**ADDENDUM NO. 2**

**MONTE VISTA ELEMENTARY SCHOOL  
INTERIM HOUSING PROJECT  
GLENDALE UNIFIED SCHOOL DISTRICT**

DSA Appl. No.03-121306  
DSA File No. 19-41

**RESPONSES TO PRE-BID RFI'S**

drawing no.:  
**E0-2**  
drawing of

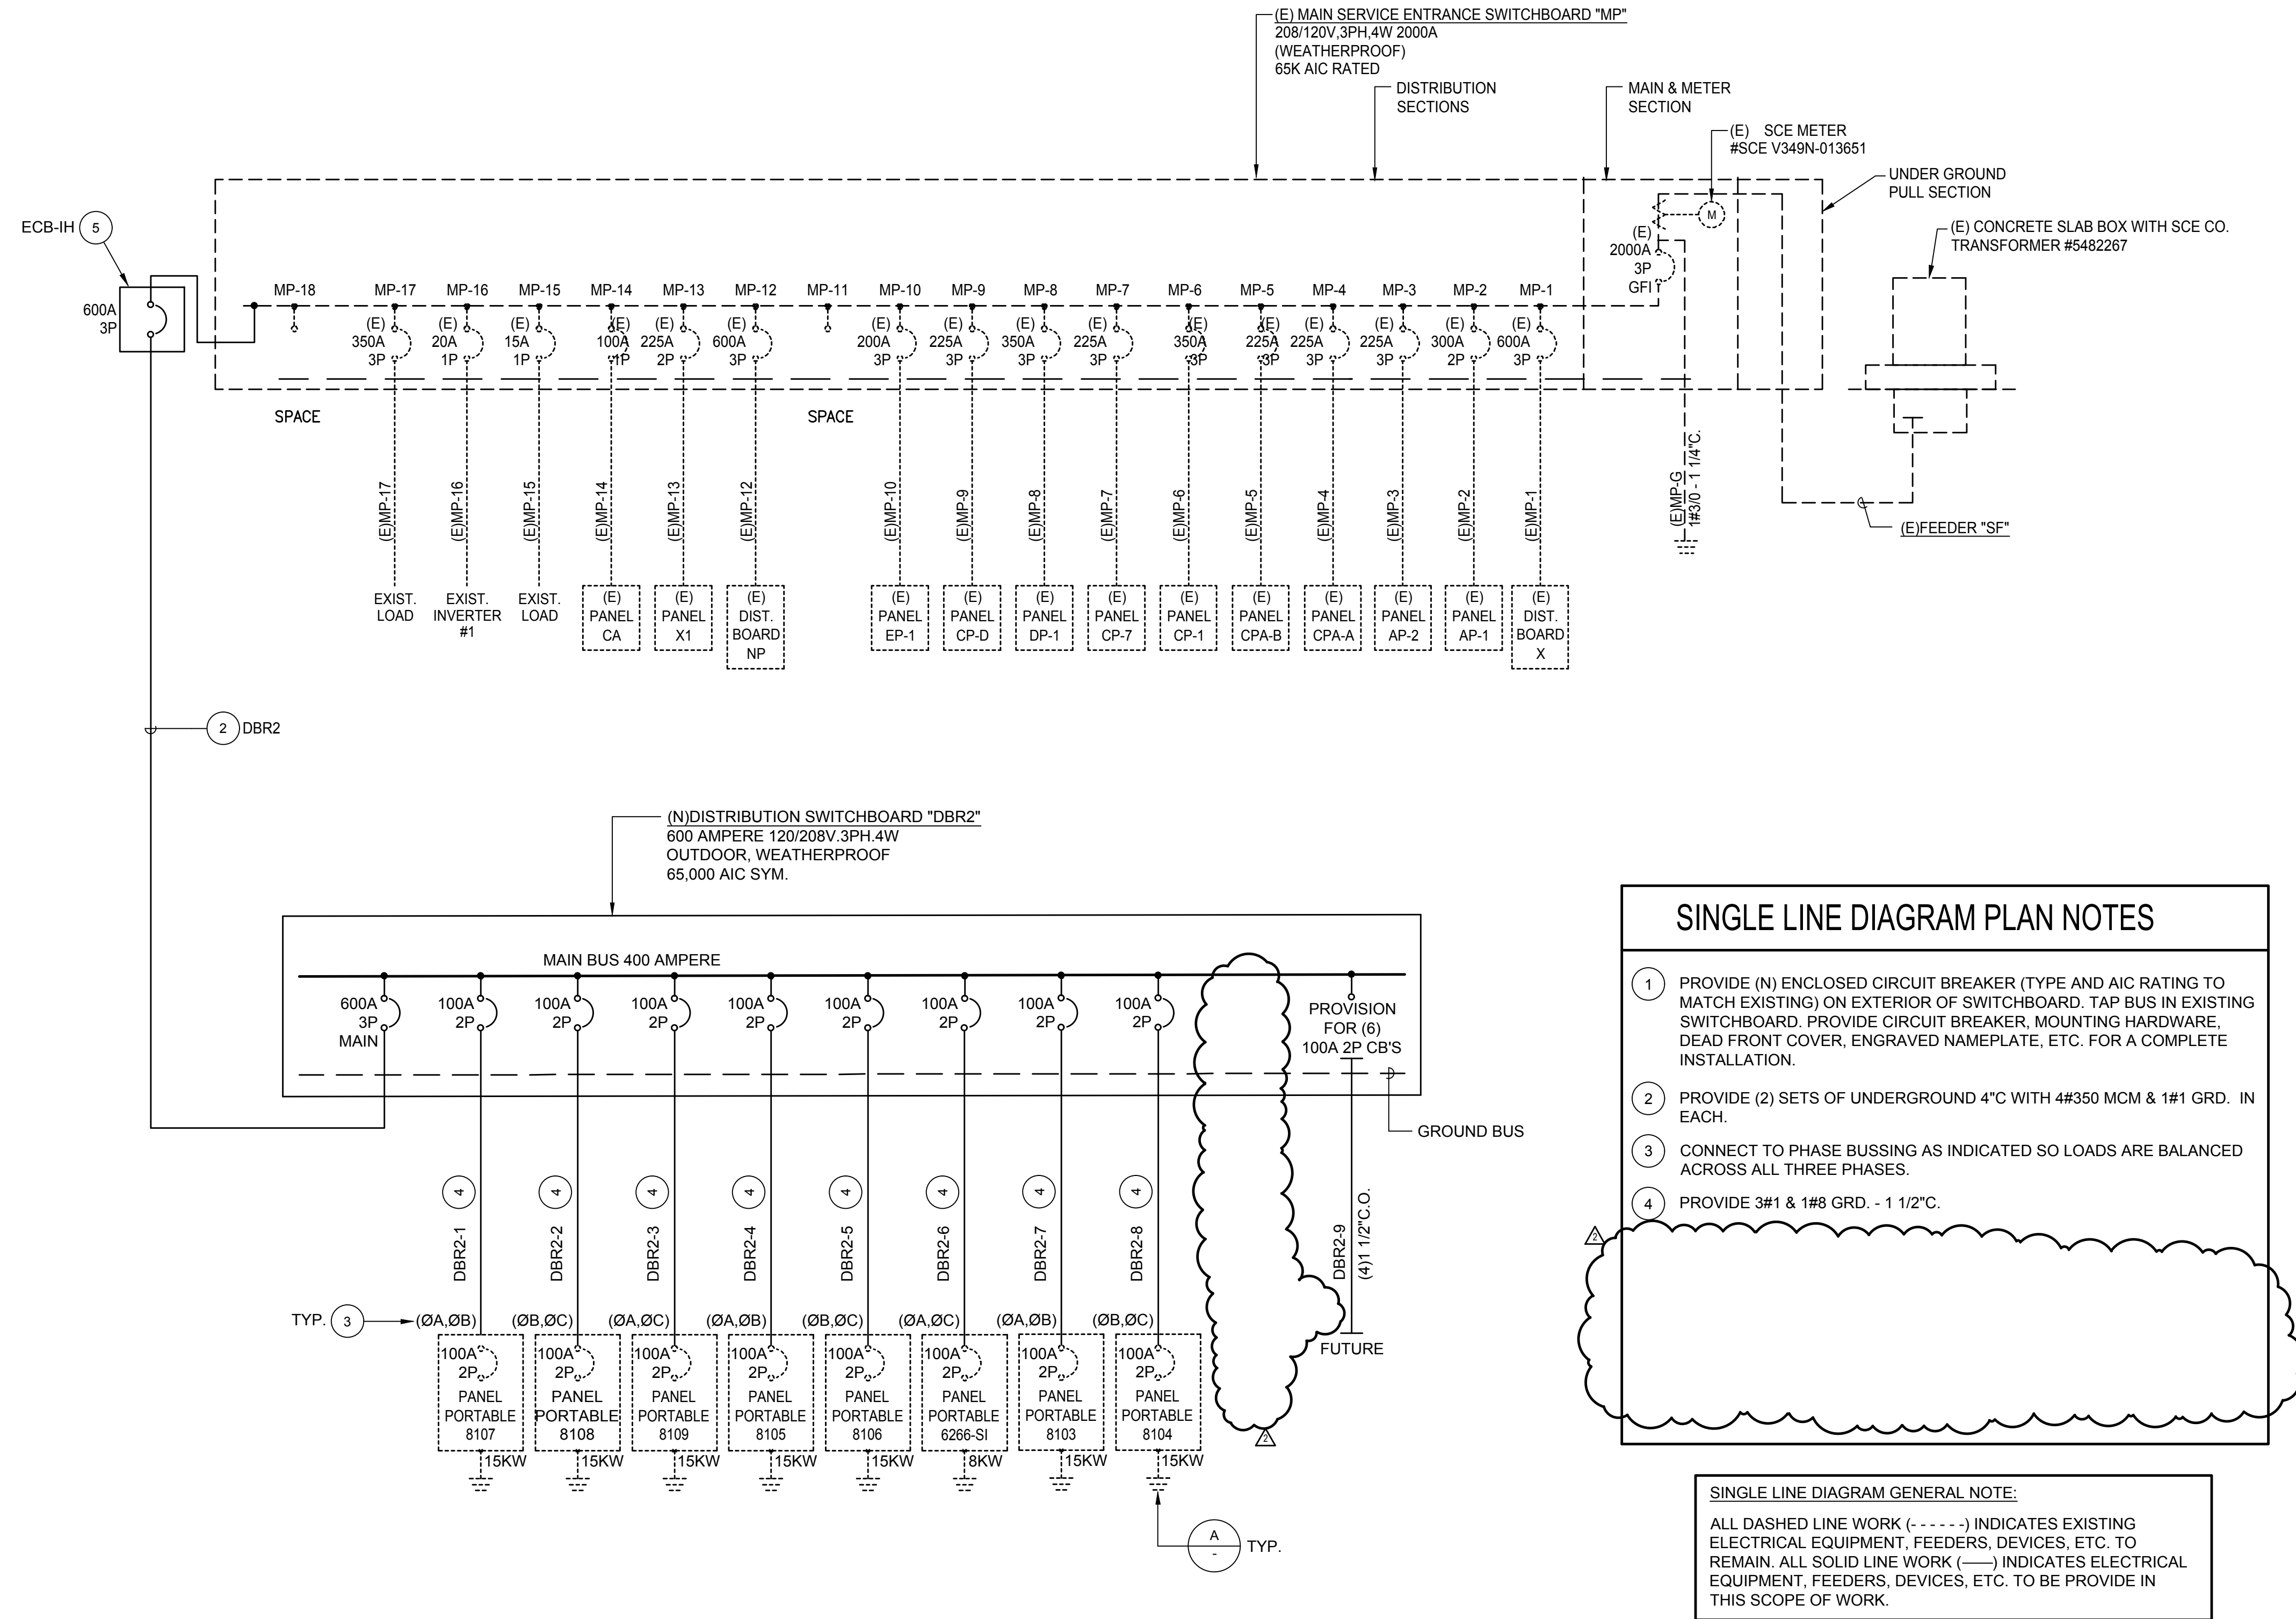
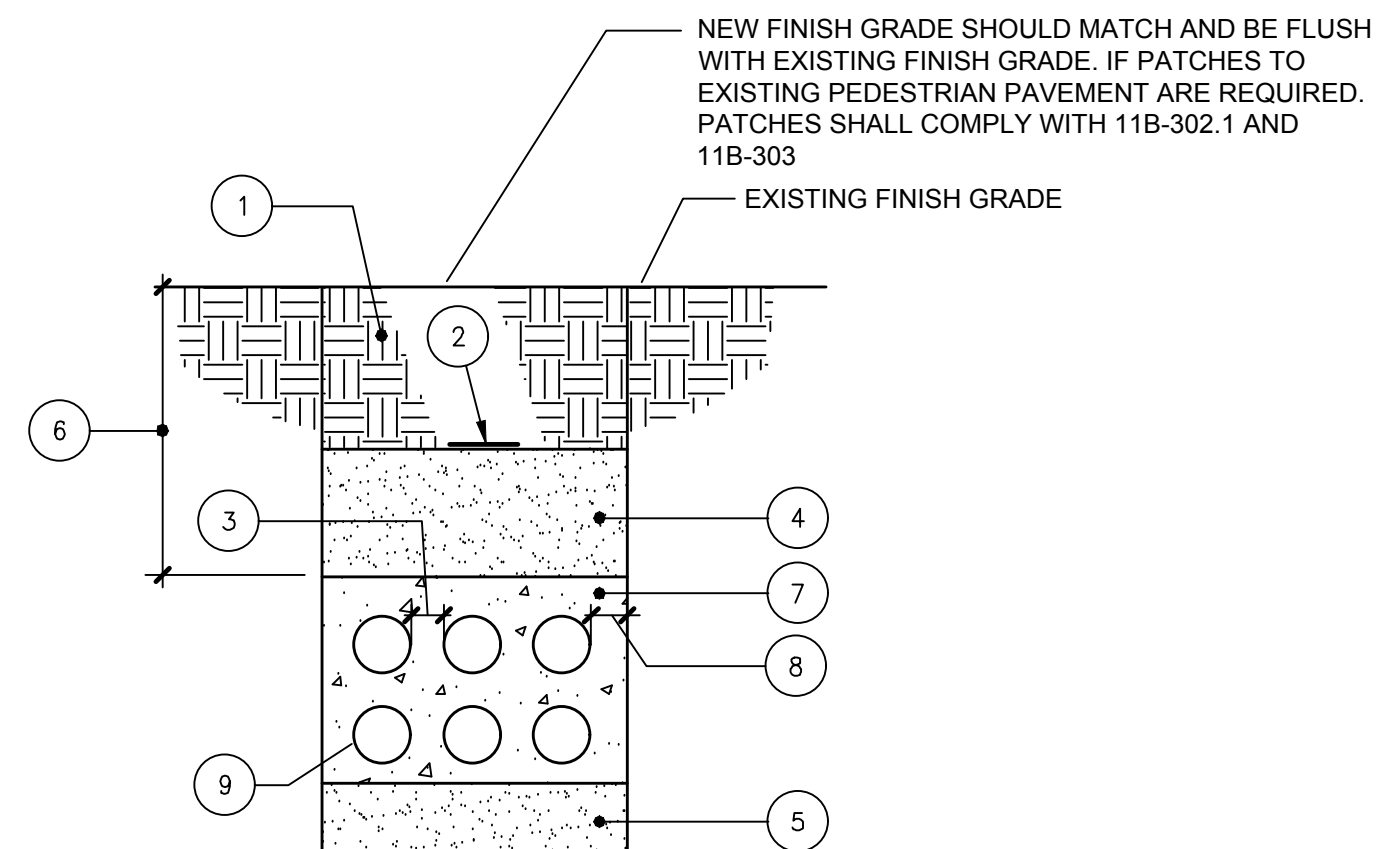
1. SHEET C004 – UTILITY PLAN  
Removed sanitary sewer ejector pump, updated keynotes, updated the potable water construction notes and added AC ramp transition notation.
2. SHEET C003 – GRADING PLAN  
Revised construction note No. 3.
3. SHEET C005 – DETAIL SHEET  
Revised detail for shut-off valve in yard box and added thrust block details.
4. SHEET AS-1 - OVERALL SITE PLAN  
Showing location of electrical trenching.
5. SHEET AS-5 - NEW CONCRETE RAMP  
Added splice and drainage requirements for retaining walls.
6. SHEET 2.01 – DETAILS  
Revise drywell detail 17/2.01.
7. SHEET E0-1 – SYMBOL LIST, GENERAL NOTES & DETAILS  
Revised grounding detail reference as shown on plans.
8. SHEET E0-2 – SINGLE LINE DIAGRAM
  - a. Deleted the feed to sewage ejector pump in Distribution Switchboard “DBR2”

1) New electrical ductbank DRB-2 as shown on E2-1 extends northerly between buildings 4, 5 and 6. Demo drawings C002 do not show site demolition, topographic survey does not show these improvements and architectural plans AS-1 do not show any restoration of site work as a result of the new ductbank.

**Response** – 1. Trenching is required for new ductbank as per detail C & D on Sheet E0-2. 2. There is no Main Electrical Room. The existing switchgear is on the exterior of the building in an electrical yard. Conduit shall be routed underground and riser up where indicated on the plans. 3. As-built plans are attached. 4. There is no main electrical room. The gear is in an electrical yard on the exterior of the building.

**CONDUIT SUPPORT DETAIL** SCALE: N.T.S. E

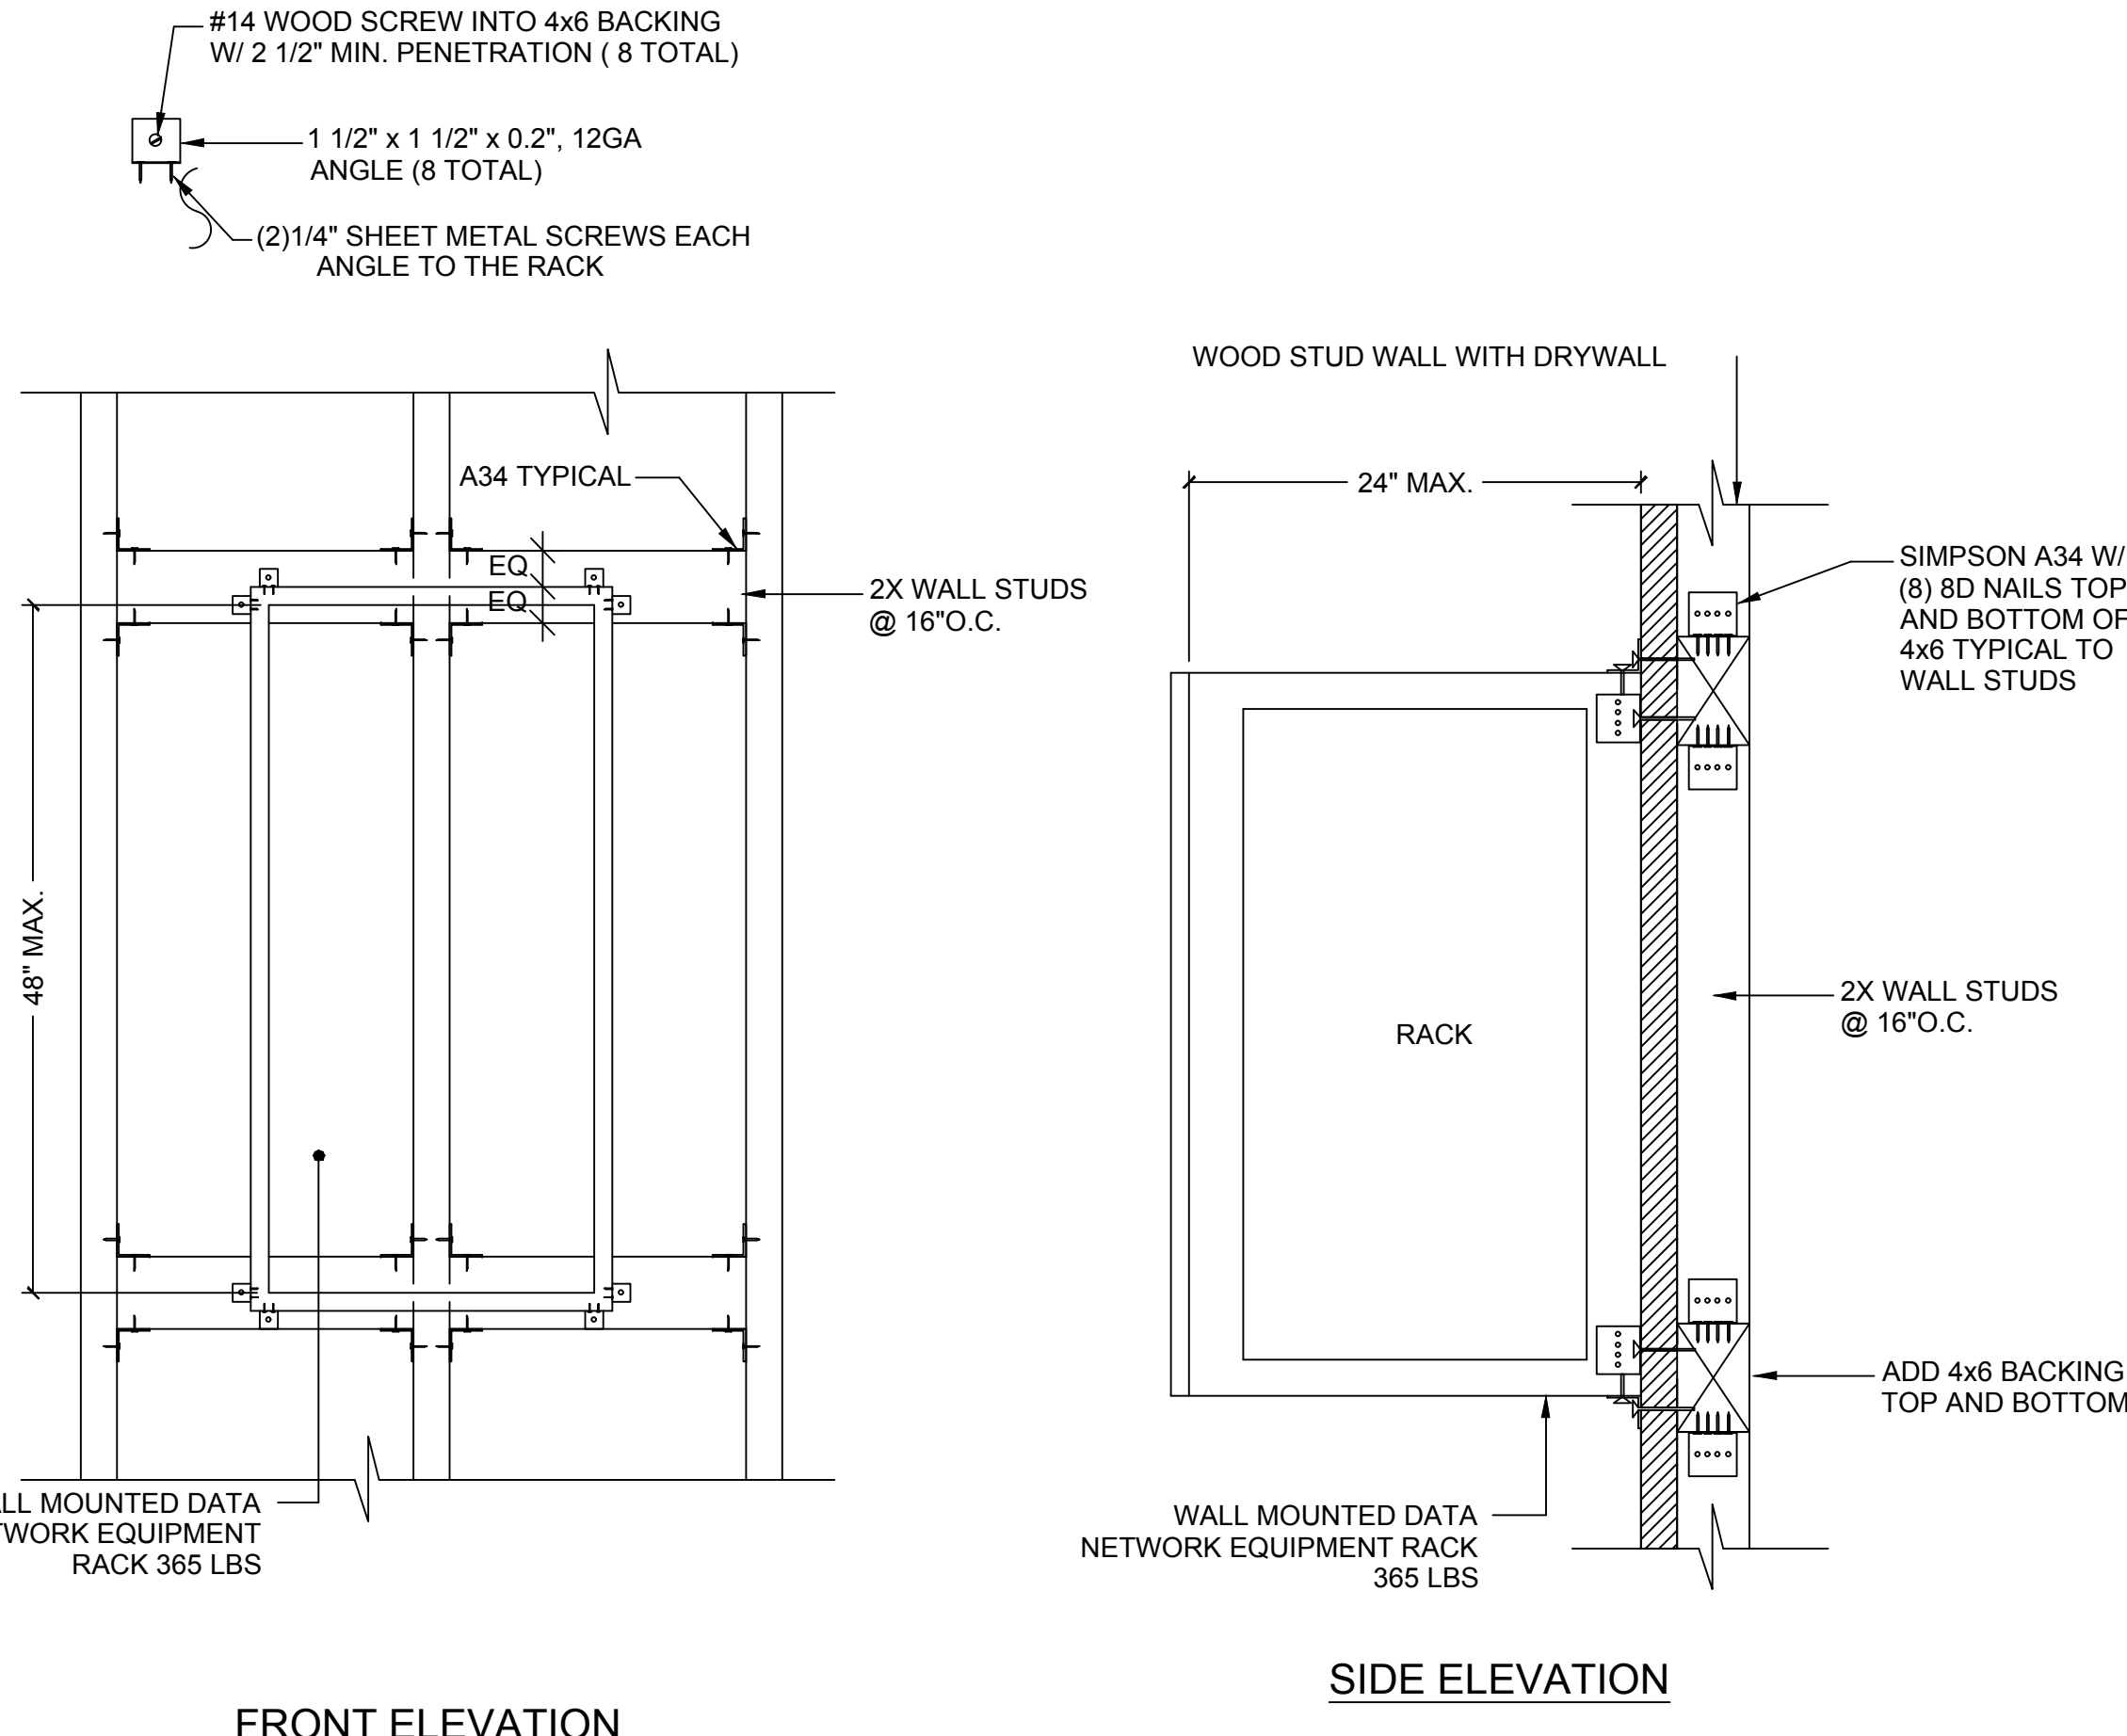
28. Reference Sheet E2-2  
Per the overall site telecom plan E2-2, (4) 2" and (2) 3" conduits will run into the Administration building. Please provide wall and ceiling mounting details. Please confirm that telcom raceways can be run exposed. Please provide report on whether exterior and interior wall surfaces and ceiling surfaces contain lead or asbestos. Please advise.

**Response** – The conduit support detail for the ceiling space has been added to the drawings in Addendum #2.  
The telecom raceways shall be concealed in the ceiling space.  
The District will take care of any abatement that is required.
